REFERENCE NUMBER: MGOZ/MPU T 72/2020

TENDER FOR THE GROUND INVESTIGATIONS AT PROPOSED SITE FOR THE CONSTRUCTION OF A BI-PARTISAN RESERVOIR AT THE GOVERNMENT EXPERIMENTAL FARM, XEWKIJA, GOZO, AS PART OF THE LIFE 16 IPE MT 008 PROJECT

Clarification No. 3

Figure 1: Proposed Section through Reservoir and Feeder Pump Room

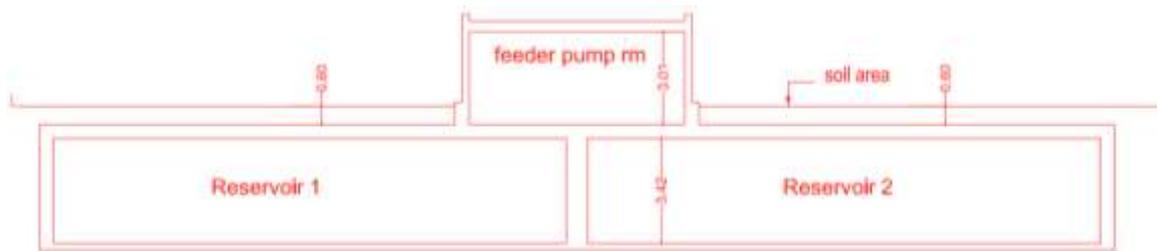
Question 1: The scope of a ground investigation is to identify the geological and geotechnical characteristics of the site. Kindly note that the geotechnical engineers at **** (bidder's company)**** would often prefer to identify these characteristics prior to quoting for the provision of allowable bearing capacity. This value represents the interaction between the ground and the proposed structure and therefore depends, in part, on what the architect or structural engineer intends to design at foundation level. In view of this, we kindly ask you to supply **** (bidder's company)**** with a site plan, set of plans and sections showing what project is being proposed. An indication of the proposed foundation level and a rough estimate of the envisaged loading at foundation level would also be very useful at this early stage. For a given site, one blanket figure for bearing capacity is often deceptively misleading, because other possible failure mechanisms may be critical. The possibility of wedge failure beneath foundations located close to rock ledges is one such example. For this reason, we prefer to give more holistic assessment, presenting those geotechnical issues that are likely to be of relevance to the safe execution of the project. We feel that we can offer a better service by discussing these with the architect or the engineer in charge, and finally by seeing how to best assist him/her in executing the project. We are therefore quoting for a geotechnical investigation with the commitment of providing a geotechnical appraisal of the site, and where applicable, the allowable bearing capacity. The latter shall however be at the discretion of the geotechnical engineers assessing the results of the investigation. Our commitment is to help the building professional in understanding the ground. In this respect we welcome and encourage discussion at all stages of our involvement, as mutual understanding often results in a much more useful investigative process.

To clarify the details in the already published Site Plan in the List of Drawings (Site Plan). A cross-section of the proposed project is provided in Figure 1 and a floor plan in Figure 2. Note that these plans are drafts and are subject to change based on the results of this ground investigation.

Figure 3: A

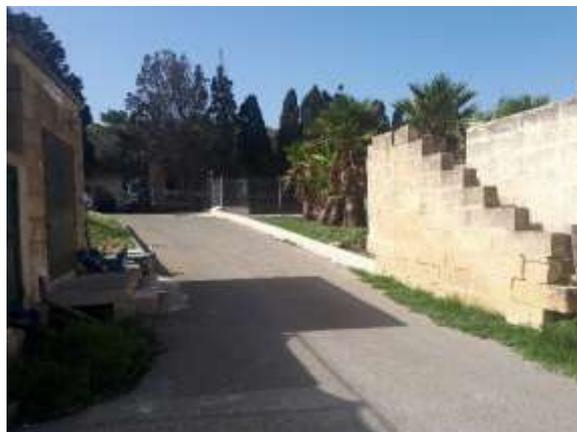
Question 3: The wall should be demolishing at least 3 meters to pass the Rig.

The attached photographs below (Figures 3-7) around the area of the Site Plan show the planned locations of the five boreholes to be drilled for this ground's investigation.

Answer 3: The Contracting Authority confirms that the wall in Figure 4 and 5 will be demolished to allow for the passage of the Rig and any other equipment necessary for the grounds investigation.
